Re: Interpretation for RZ 2001-SU-055, Compton-Berry Subdivision
Tax Map 65-1 ((1)) 39: Limits of Clearing and Grading

RE: Compton-Berry Subdivision
REZ 2001-SU-055 and 8783-SD-04-1

INTERPRETATION PLAN

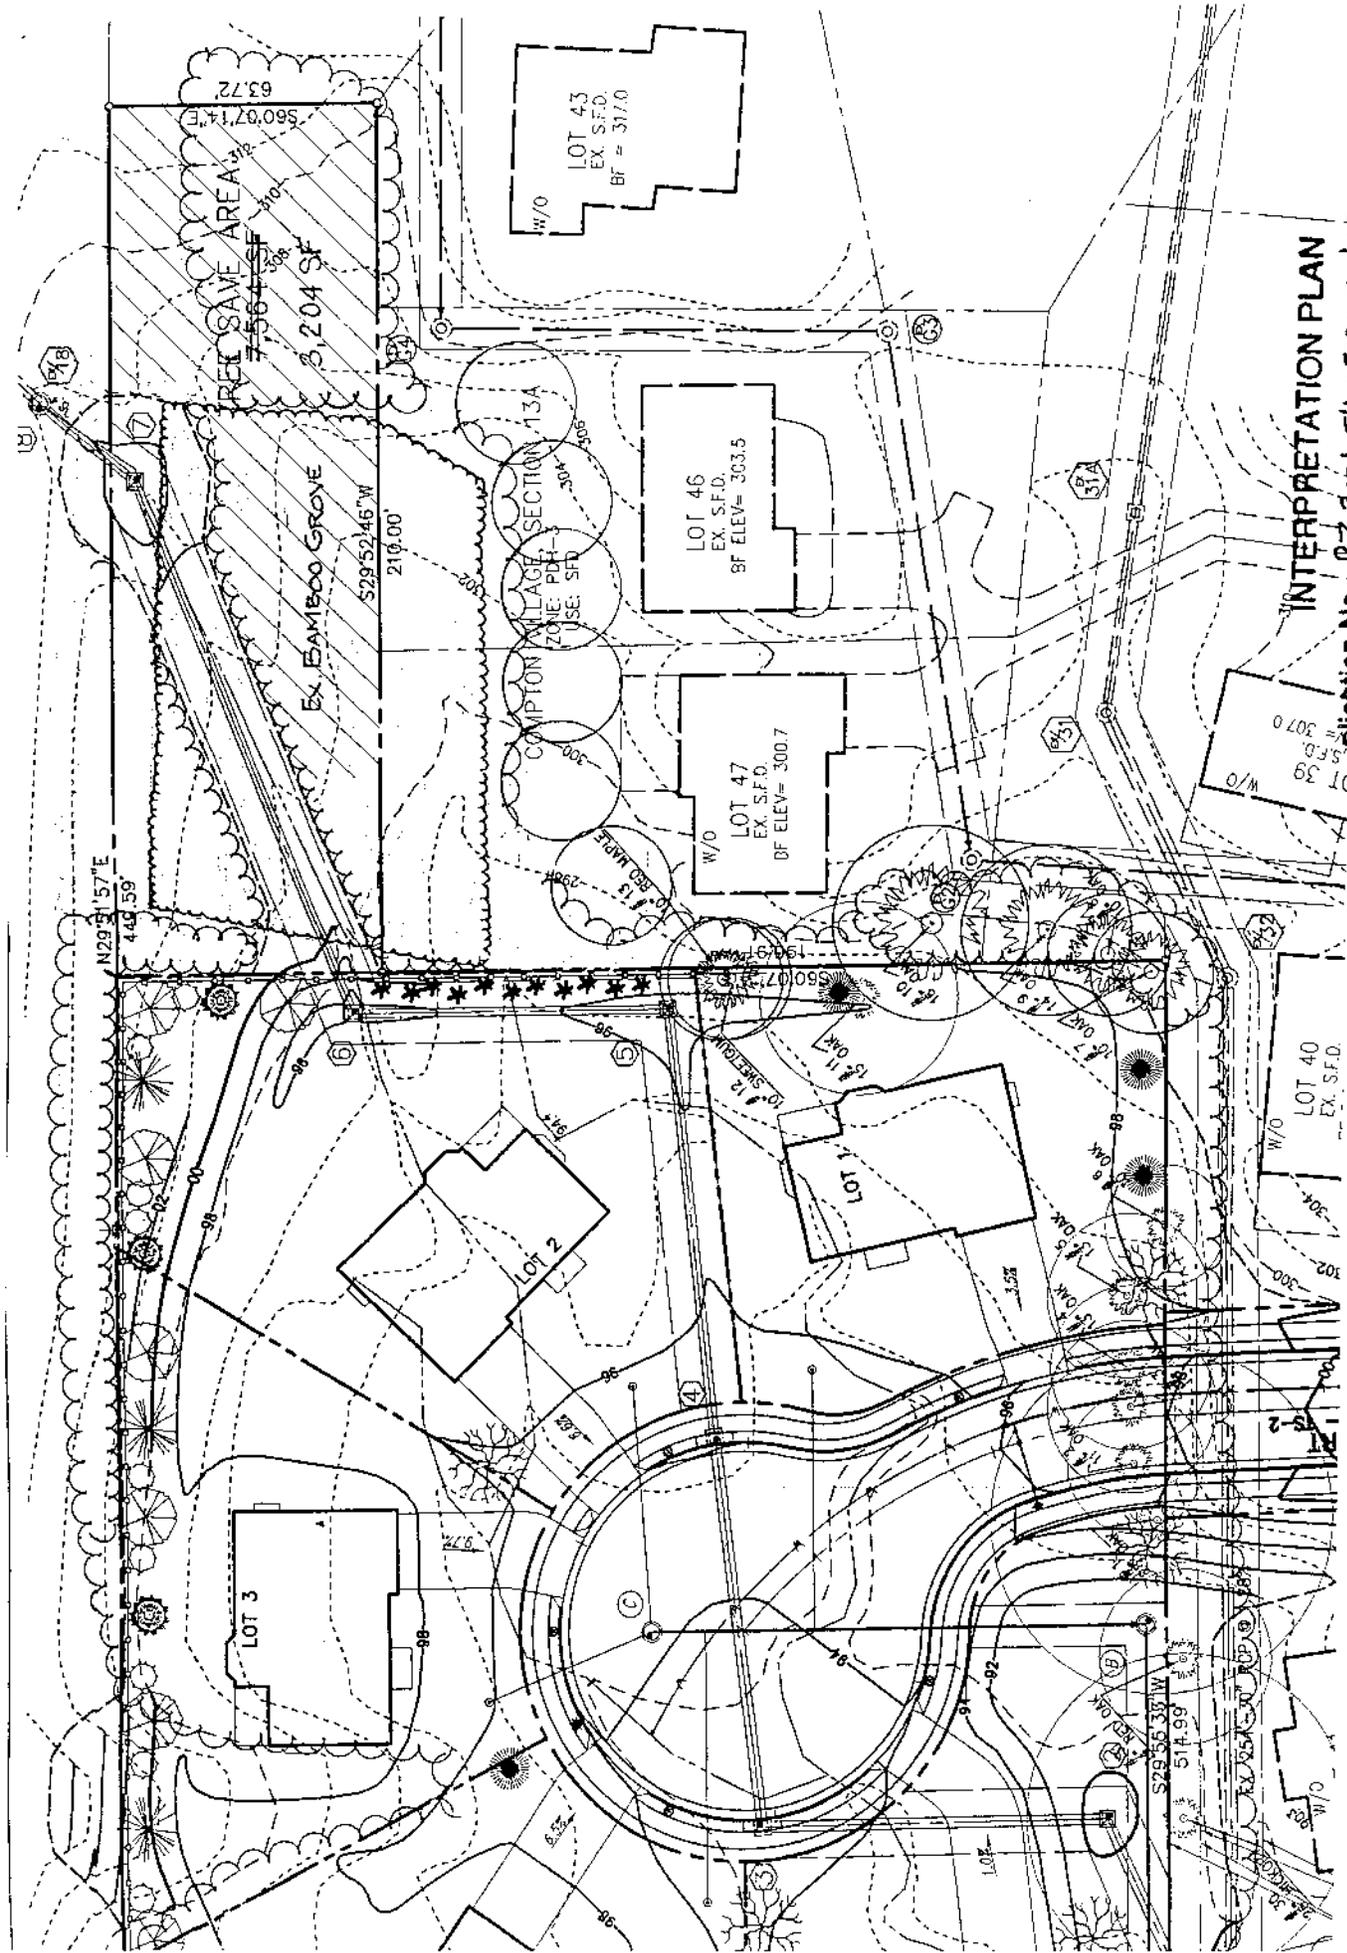
We have proposed to place the drainage in a closed system across Parcel A which will result in the creation of an easement, construction land disturbance and removal of some of the bamboo. We therefore have been requested to get your review and approval of our subdivision plan since there is some variation to what was shown on the approved GDP. This issue arose when our first submission plan showed the storm sewer extending through a Tree Save Area. However, that may be a mute point if bamboo is a grass. We have revised the Landscape Plan (Sheet 10) to

show the existing tree line and area covered by the bamboo. We have also revised the Tree Canopy calculation to reflect the existing conditions. We are now only taking credit for 3,204 SF of tree preservation area on Parcel A. That area consists of 19 mixed hardwoods and cedars and is the only area of the parcel with trees. We will not be disturbing any trees to construct the storm sewer system, only bamboo.

It is my determination that the proposed disturbance and clearing of vegetation for the construction of a storm sewer on Parcel A would not be in conformance with GDP and the proffers. This determination has been reviewed with Office of Site Development Services, DPWES and has been made in my capacity as the duly authorized agent of the Zoning Administrator.
